Feedback of 2025 IDRC Review Report

中國科學院高能物理研究所
Institute of High Energy Physics
Chinese Academy of Sciences

Figure 6.21: Charge density in the TPC as a function of radius (average in φ and z direction already) and fitted by an empirical Equation 6.2, (Magenta dashed line in the plots). (a): H mode (b): Low luminosity Z mode.

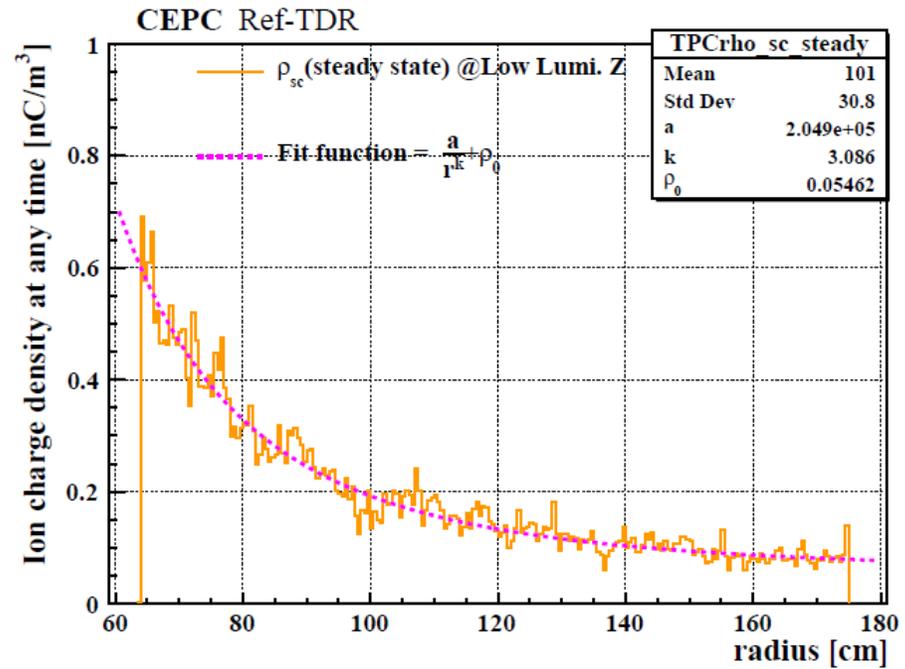
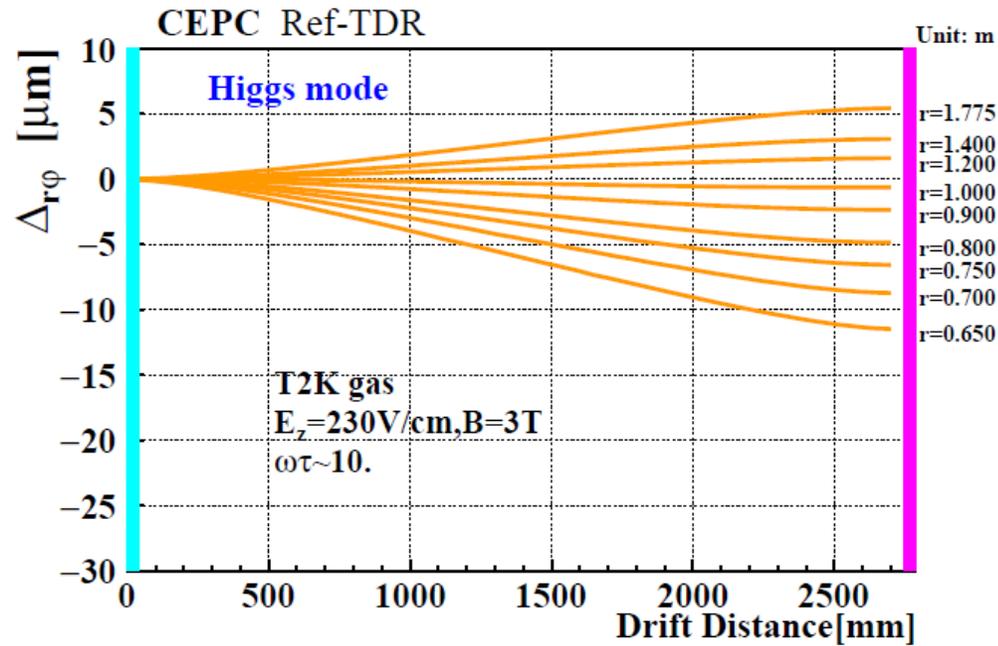
- The chapter still lacks a quantitative description of space-charge distortion and its impact on tracking;
- The description of space-charge distortion and its impact on tracking have been added in the subsection of 6.3.2.4 (TPC space distortions estimation). The detailed R&D of its impact on tracking will do in next steps.
- There is no indication or explanation of how correction strategies (e.g., ALICE-like data-driven approaches) can be implemented, at least qualitatively;
- The brief description of the correction strategies have been added in the subsection (Calibration and alignment).

- Reducing the beam lost rate.
 - Added shielding after the lumiCal.
 - Added a dedicated distortion correction in the section of Calibration and Alignment

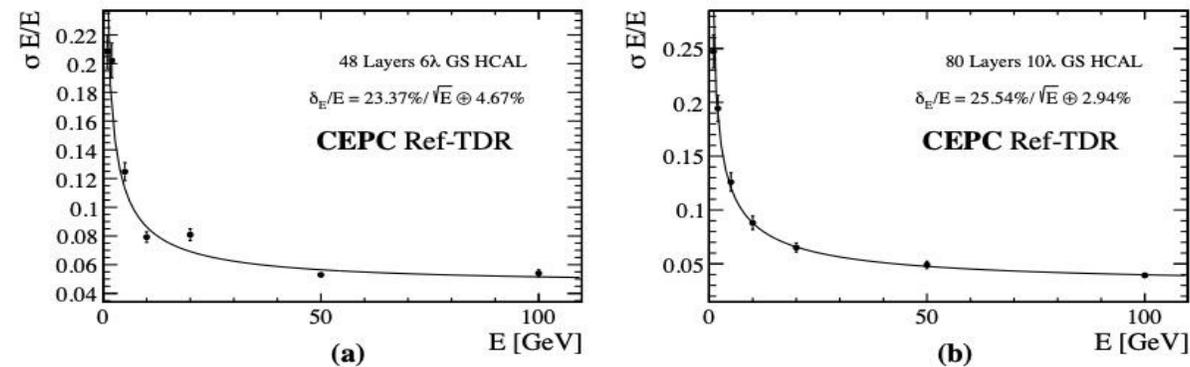
- F-A-8-3: For instance, during the review, the team was uncertain about the origin of the constant term observed in the hadronic energy resolution, a result obtained from idealized simulations with only limited hardware effects included.
- --To verify the hypothesis that longitudinal leakage was the cause of the observed discrepancy, we increased the depth of the GS-HCAL from 48 layers ($6 \lambda_I$) to 80 layers ($10 \lambda_I$) in **Section 8.5.2 Hadron Energy Resolution**. When the calorimeter depth was extended to 80 layers, this tail decreased significantly, and the constant term dropped to around 2.9%. The significant improvement in the constant term upon increasing the depth of the GS-HCAL supported the hypothesis that shower leakage, rather than an intrinsic design flaw.

Figure 8.12: (a) Transmission and XEL spectra of large GFO glass, (b) Energy spectra of GFO GS and BGO crystal with same dimension. (c) Scintillation decay curve of the GFO glass.

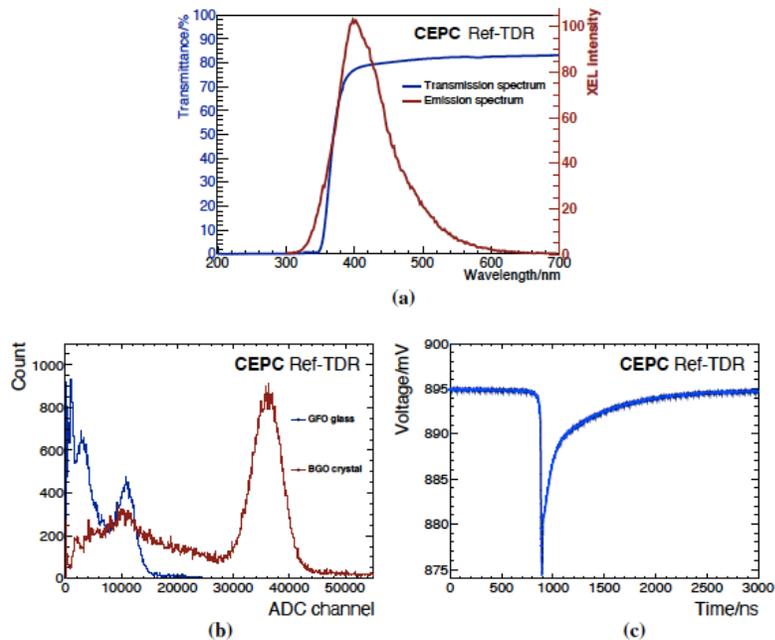
- o C-A-8-4-3: For example, it is unclear why the emission spectrum shown in Fig. 8.52 is included—is it representative or used for digitization? This should be explicitly explained.
--this figure was deleted. Totally about 91 figures aere deleted, and all the figures in the new version TDR were modified with high quality.

--In Fact, in the Section **8.4.2 Glass Scintillator**, the **Figure 8.12**: the transmission and XEL spectra of large GFO glass, the Energy spectra of GFO GS and the Scintillation decay curve of the GFO.
